ONKYO®

DPC-6.1

Ref: 112200-3

Service Tip and Troubleshooting:

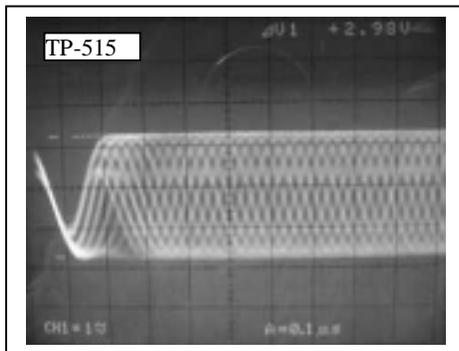
B: Disregarded Step 3 of page 45 and make correction as follows.

The reference should be:

$$\text{lop} = \frac{\text{Voltage between E522 and E523}}{3.3\text{ohm}}$$

The voltage drop across R505 (3.3ohm) resistor is higher than 218~238mvDC in normal operating condition and the LD is not on connection (Fig1 A, B and or Fig2 C) may be loose or poor. This indicates the LD is not present as load to the voltage rail R505.

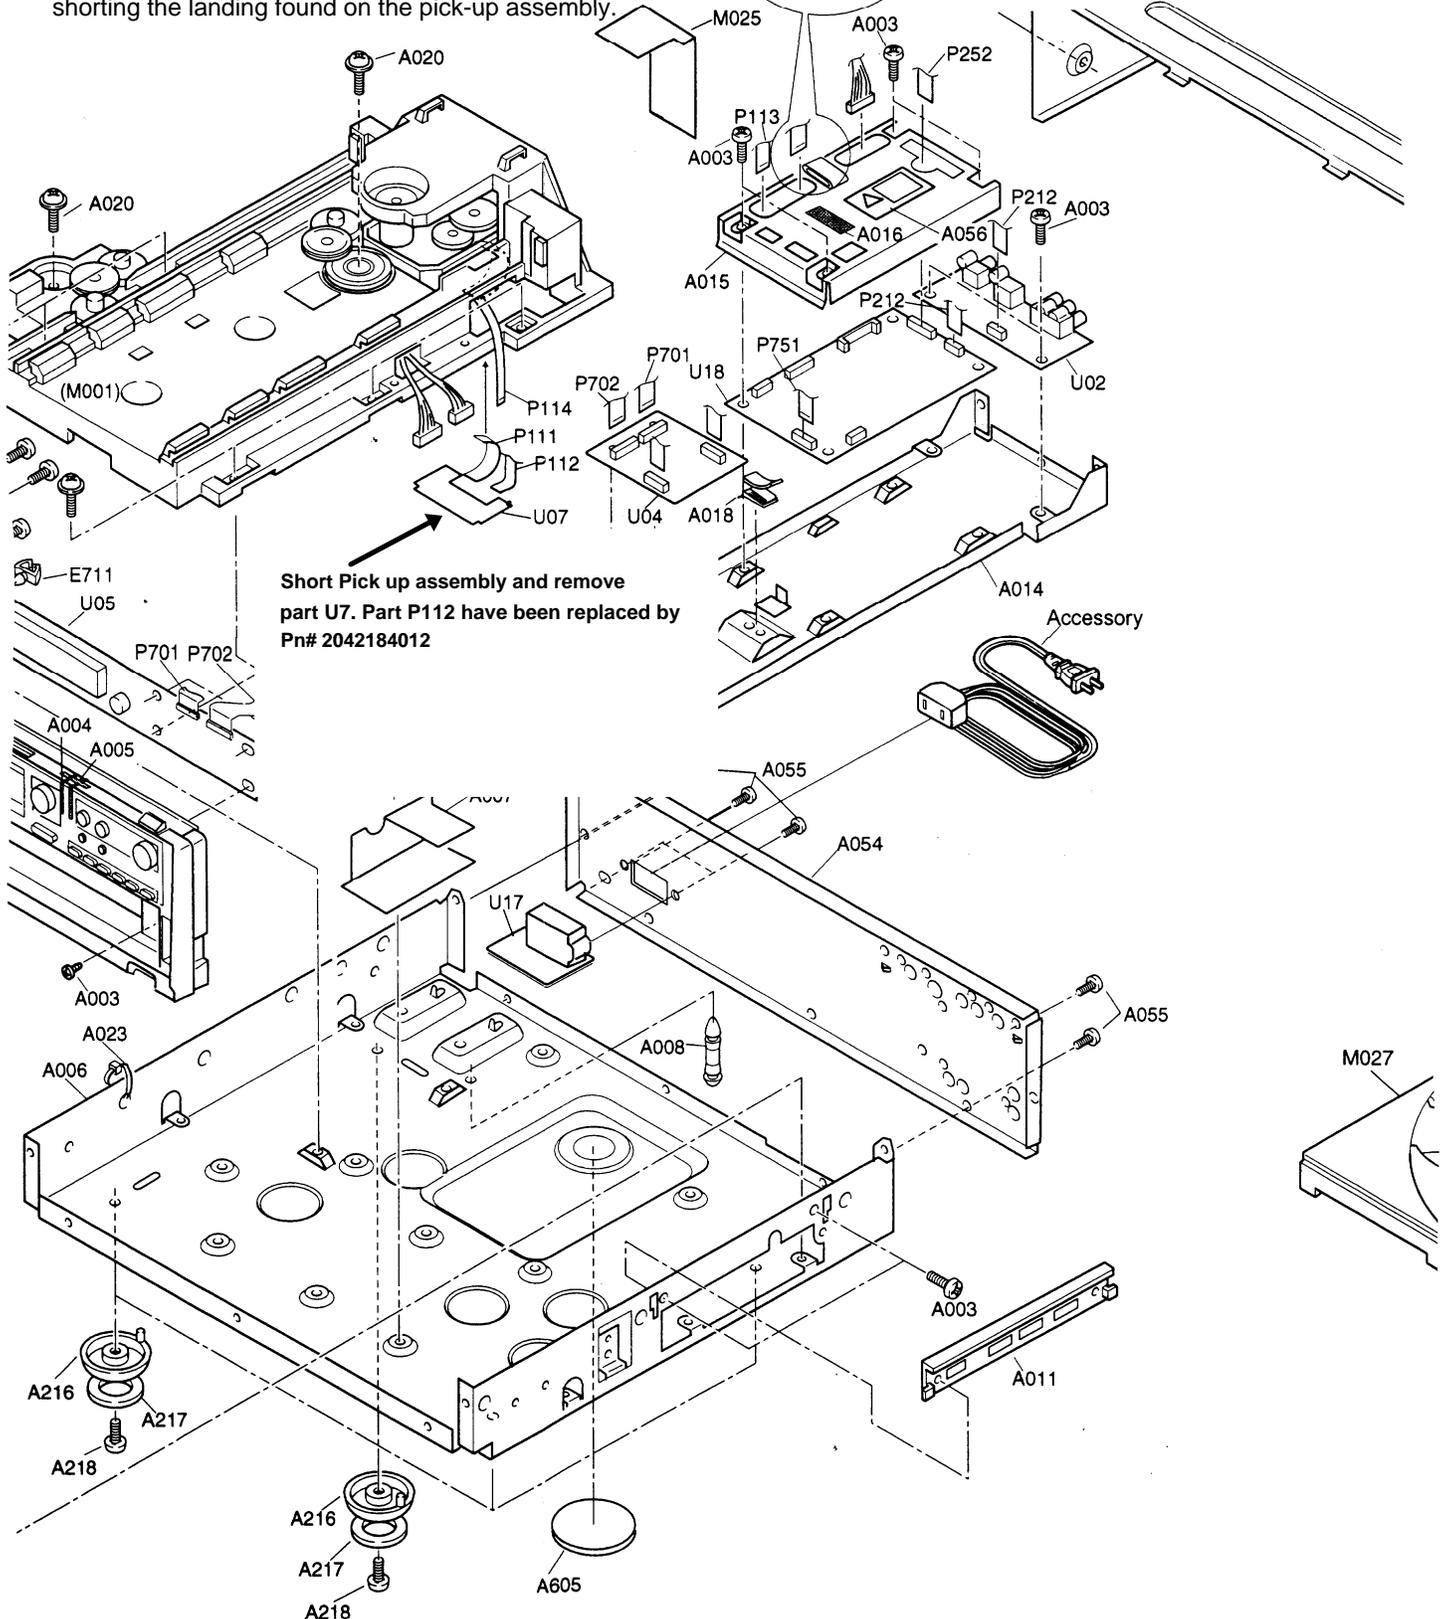
Before replacing a pickup assembly it is important that the following component change is addressed properly. Do Not Attempt to Remove Optical Ribbon cable before shorting the landing found on the pick-up assembly.

Must add ferrite core
PN#230957 or 230951
